MEMORANDUM

RE: MAJ-25-0002 (121 E Main Street) Major Site Plan Engineering Review

Name of Development: Sixth Degree Town Homes

SHEET C-1

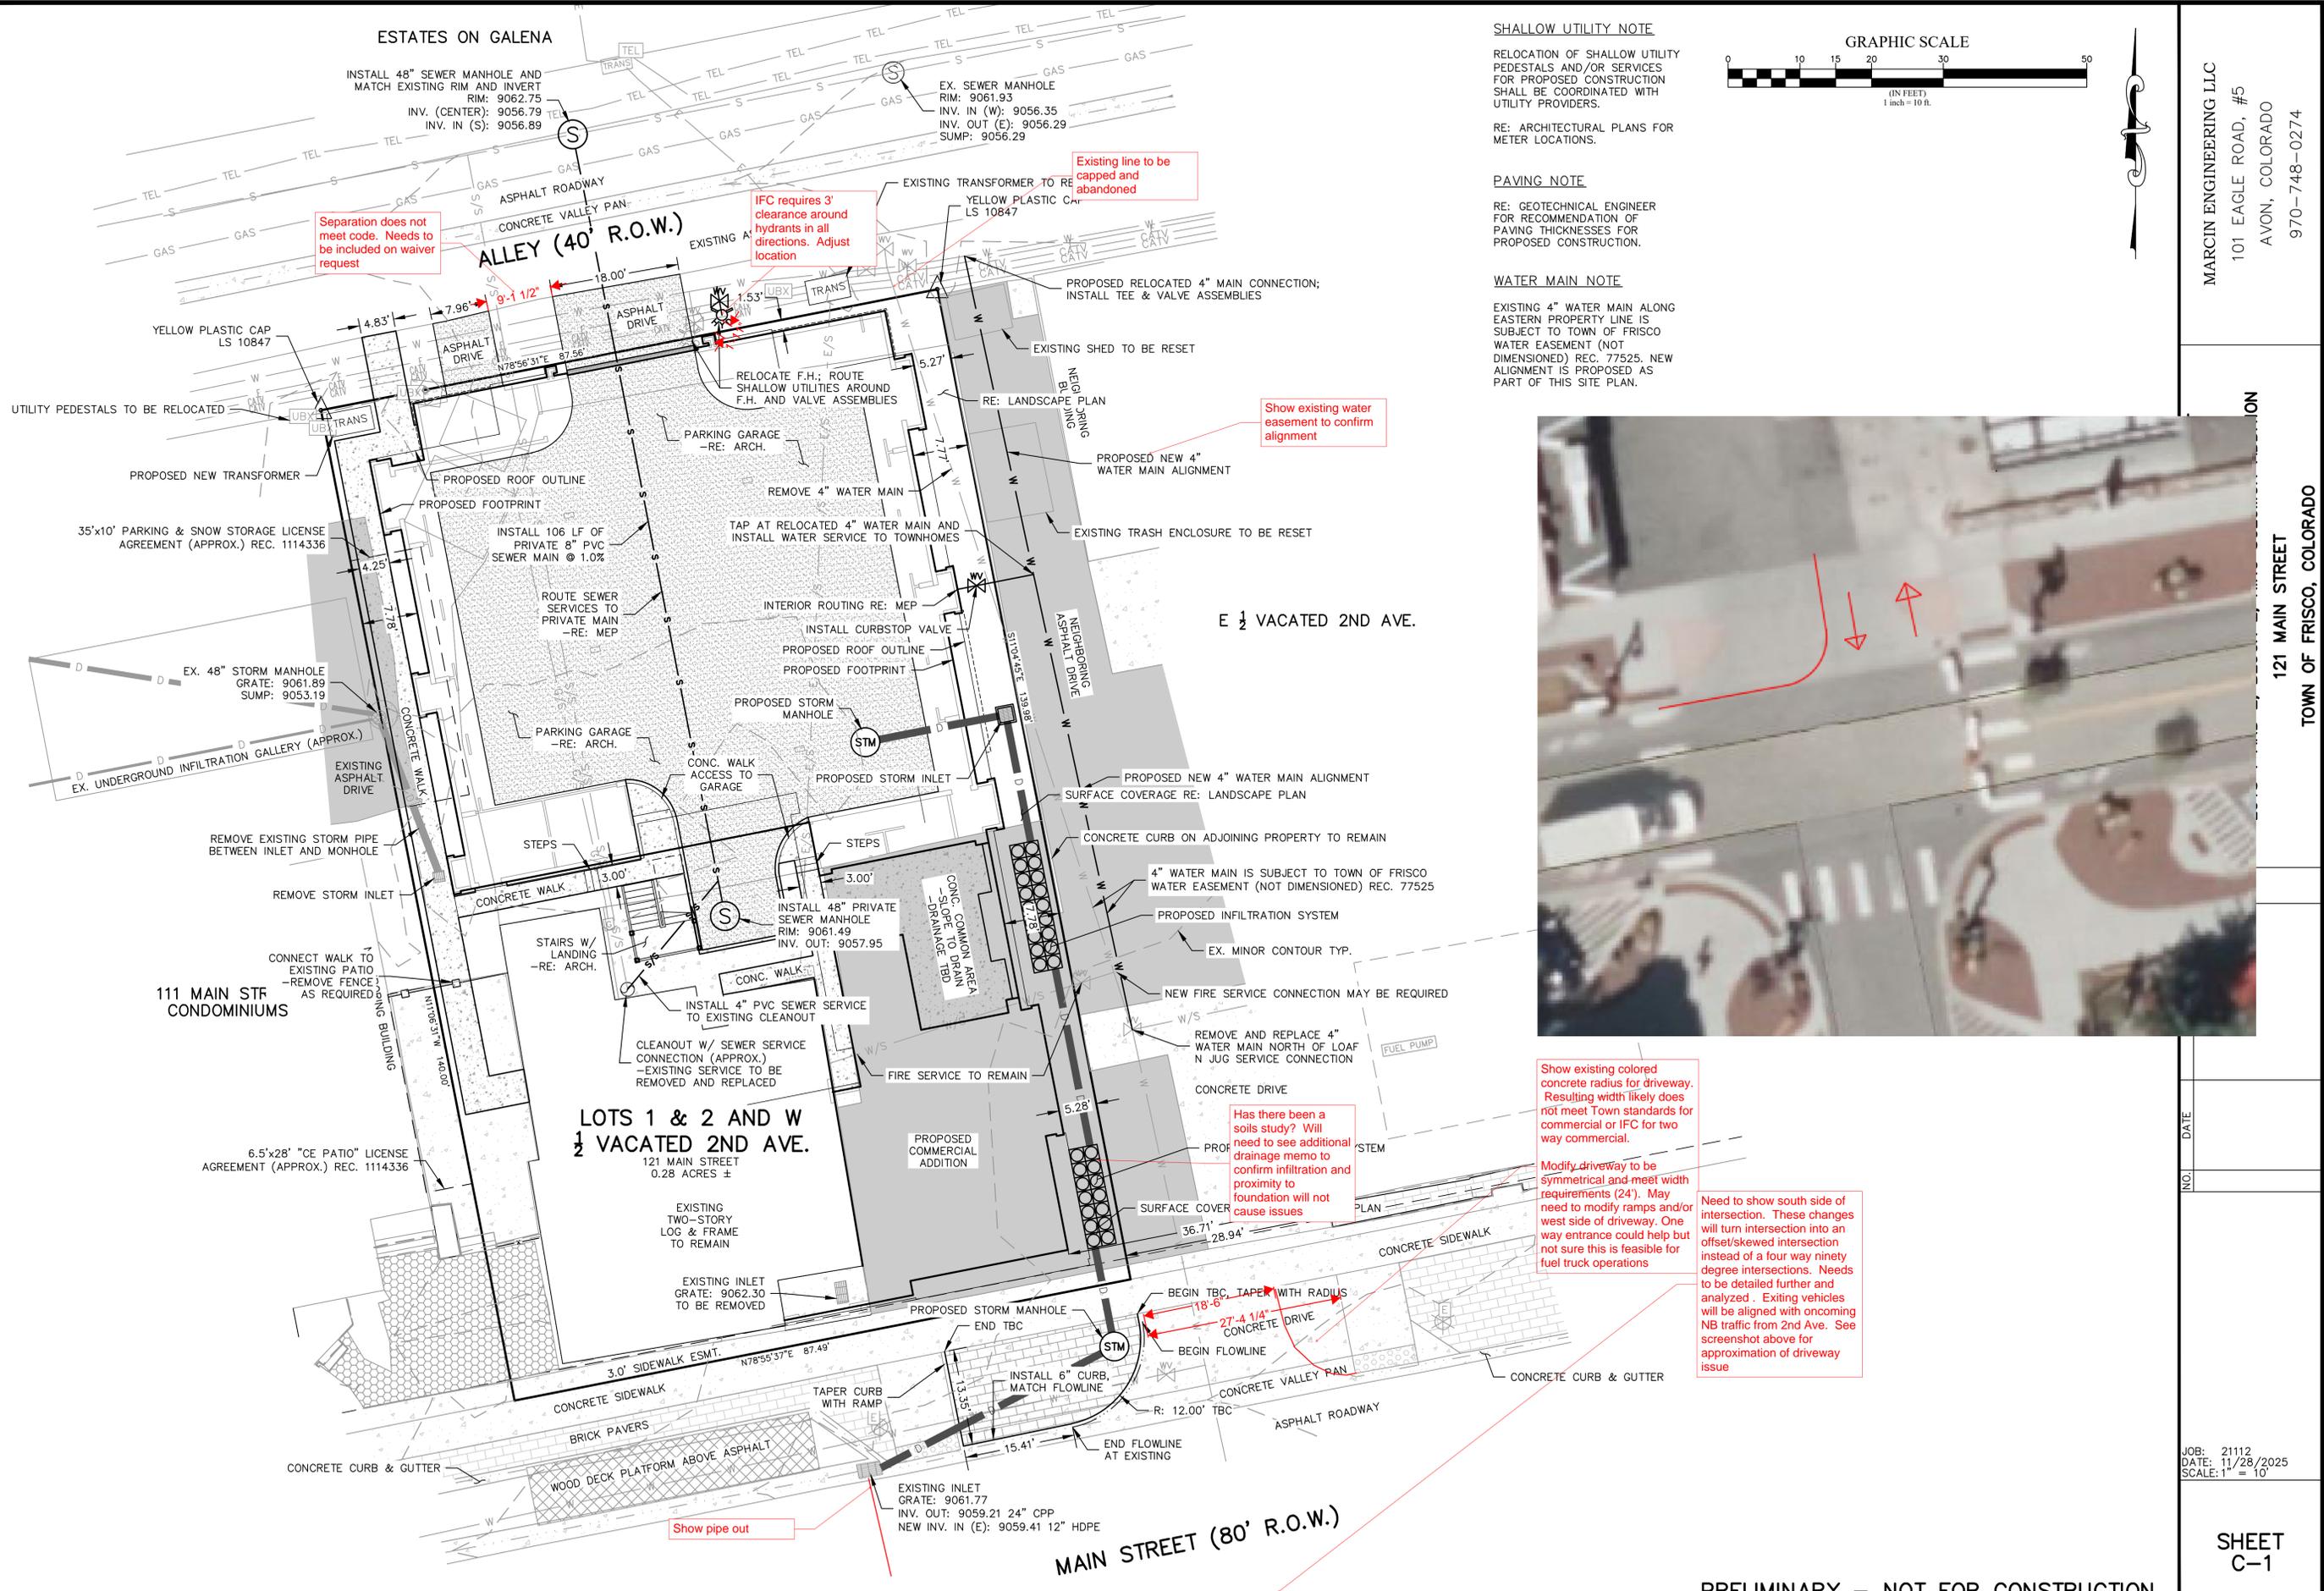
Show existing water easement to confirm alignment

Show existing colored concrete radius for driveway. Resulting width likely does not meet Town standards for commercial or IFC for two way commercial.

Need to show south side of intersection. These changes will turn intersection into an offset/skewed intersection instead of a four way ninety degree intersections. Needs to be detailed further and analyzed. Existing vehicles will be aligned with oncoming NB traffic from 2nd Ave. See screenshot above for approximation of driveway issue

Show pipe out

© 2024
 SHEET NUMBER:
SP-1.3
 PROPOSED
 PARKING PLAN

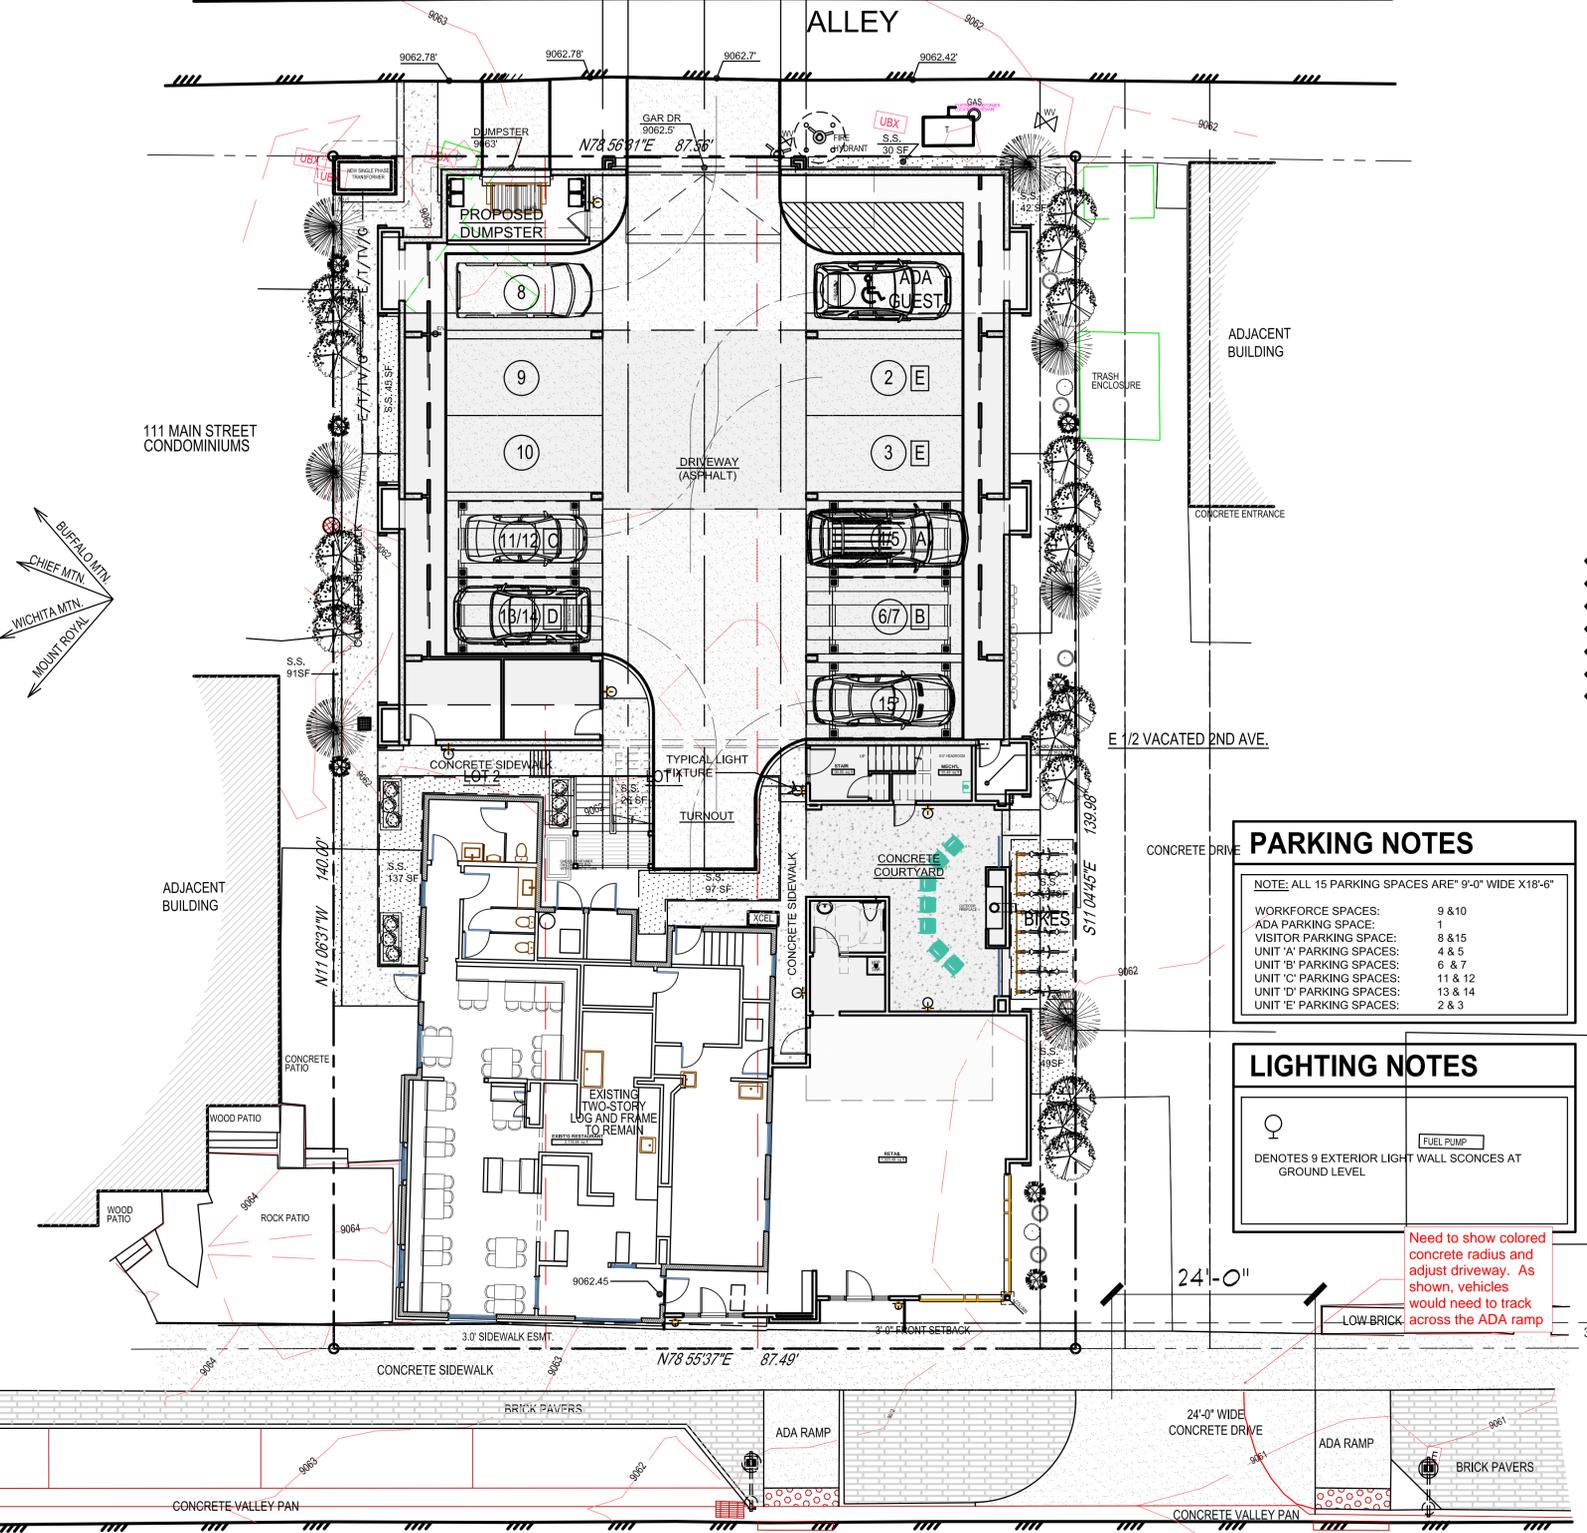
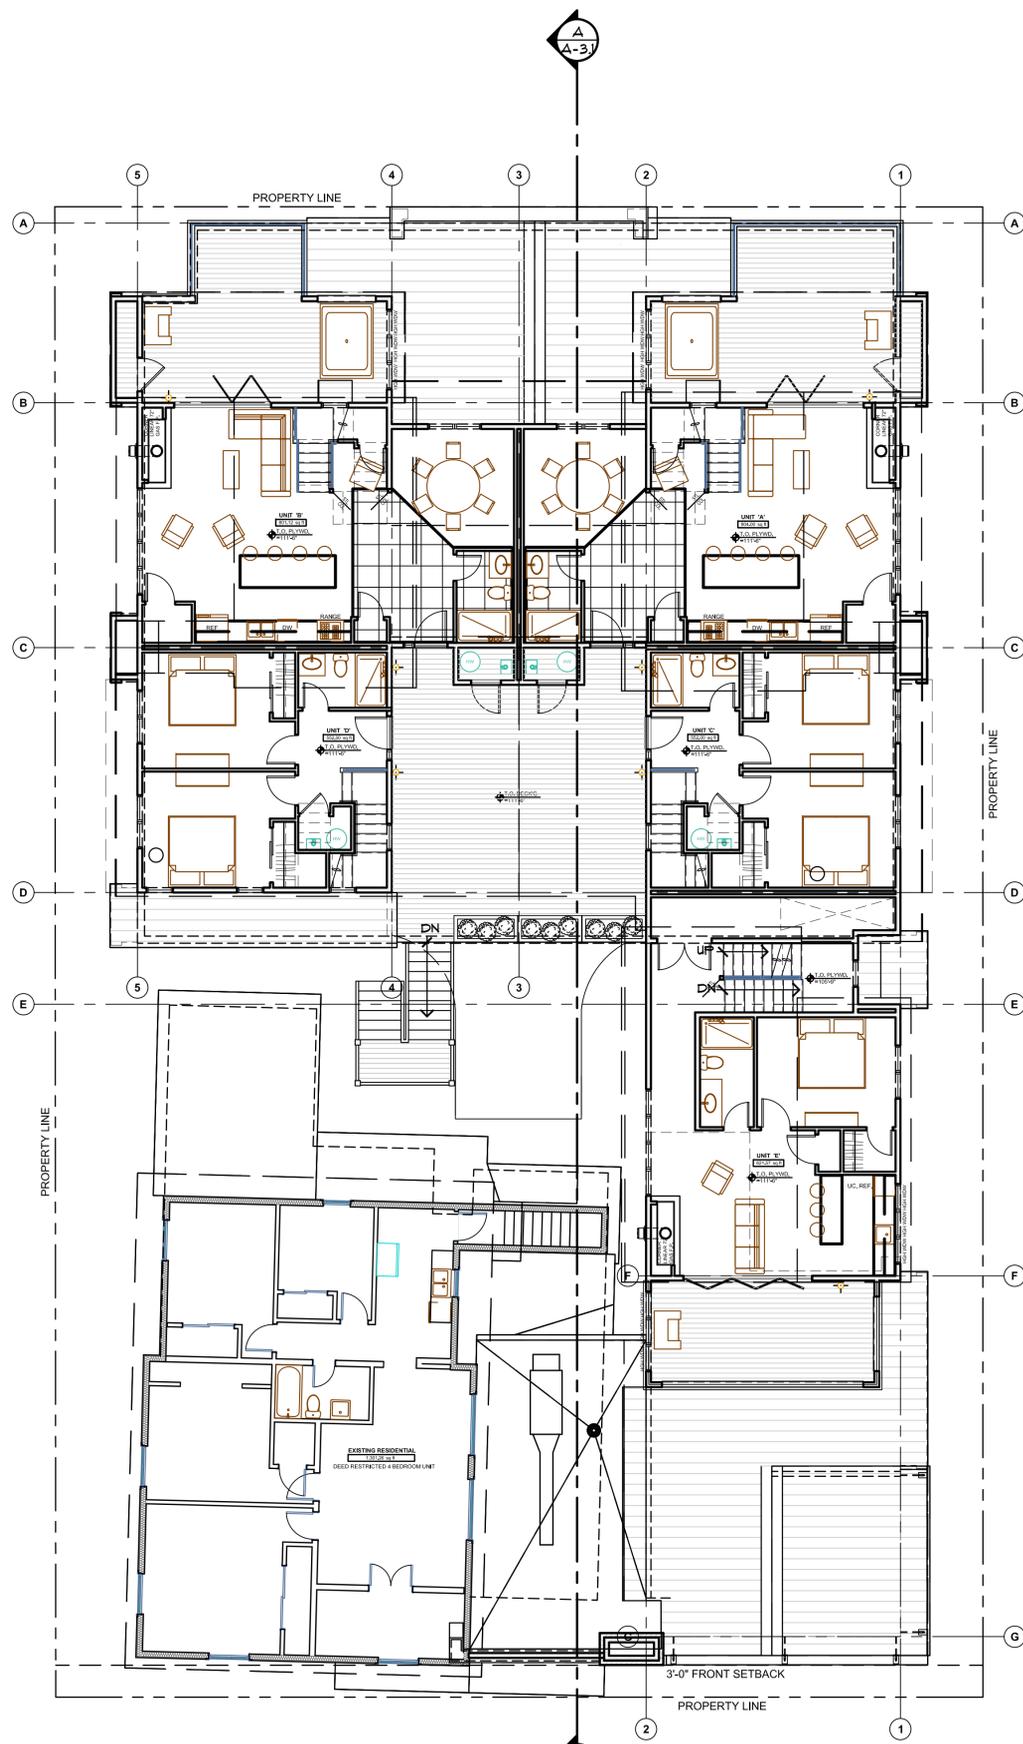
Need to show colored concrete radius and adjust driveway. As shown, vehicles would need to track across the ADA ramp
